**BEFORE A COMMISSIONER PANEL APPOINTED BY CHRISTCHURCH
CITY COUNCIL AND CANTERBURY REGIONAL COUNCIL**

In the matter of an application by Christchurch City Council for resource consent to establish and operate a wastewater treatment scheme and associated discharges to land as part of the Akaroa Treated Wastewater Irrigation Scheme at 80 Old Coach Road, Akaroa, 11 Sawmill Road, Duvauchelle, 6583 Christchurch Akaroa Road, Akaroa, and Jubilee Park, Akaroa (RMA/2023/1347, CRC235038, CRC235039, CRC235040 and CRC235041)

**SUBMISSION TO THE ATWIS HEARING PANEL
PRESENTED BY
MS SUKY THOMPSON, DR BRENT MARTIN, JAN COOK
ON BEHALF OF
FRIENDS OF BANKS PENINSULA INCORPORATED**

11 February 2025

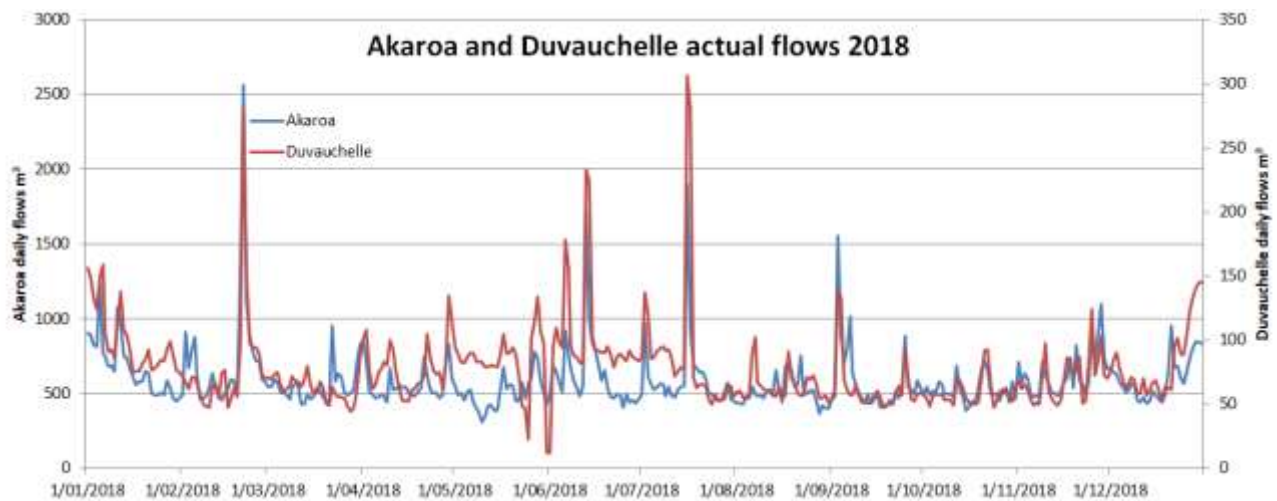
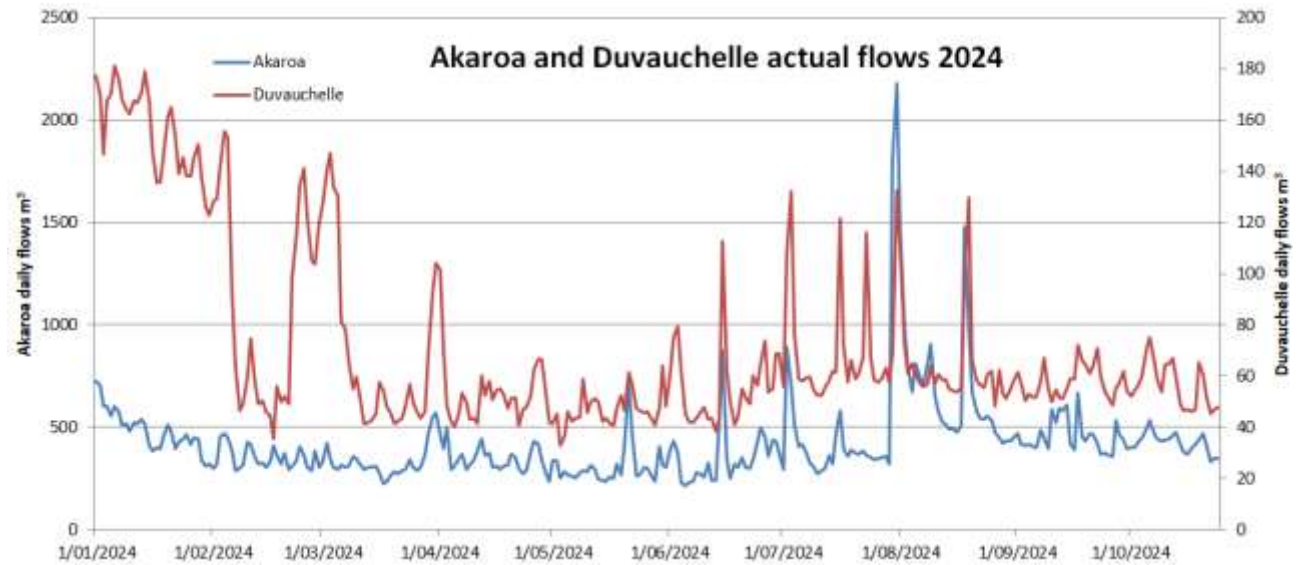
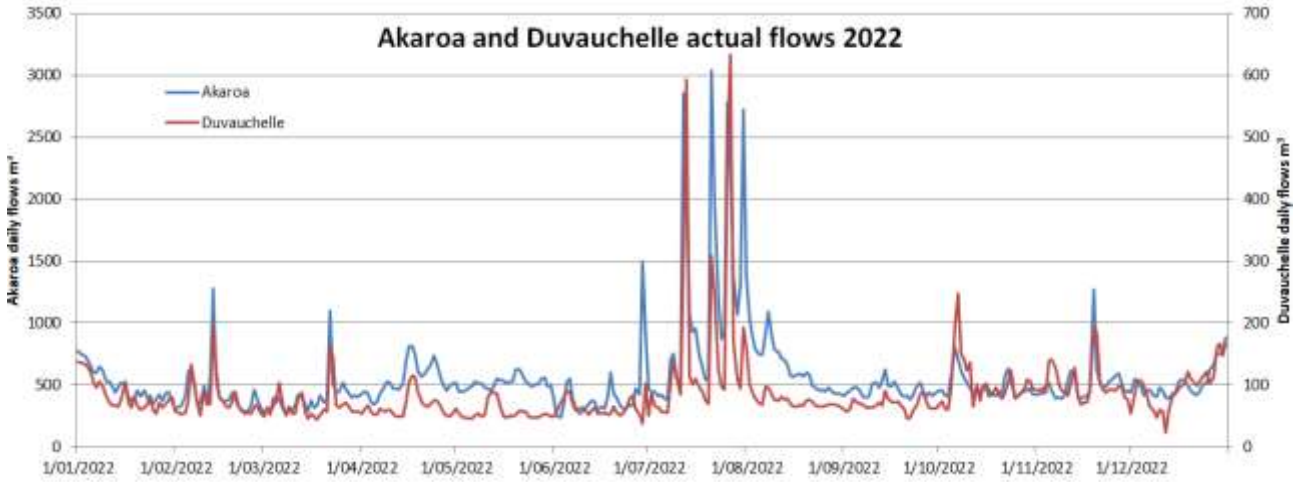
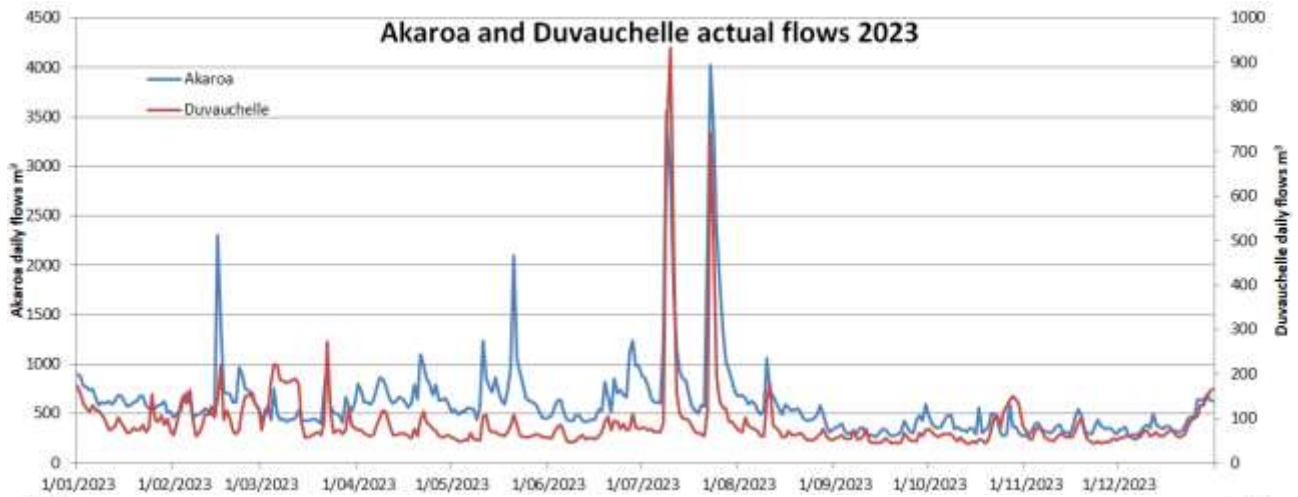
The graphs below show four example years comparing Akaroa and Duvauchelle flows. 2018 is an average year. 2022 and 2023 were wet years. 2024 is a dry year.

The main point to note is that peaks generally coincide. Therefore the use of the same storage by the two communities does not result in much offset. Occasionally there is some offsetting, but in general Duvauchelle is spiking at the same time as Akaroa, increasing the storage requirement or exceedances.
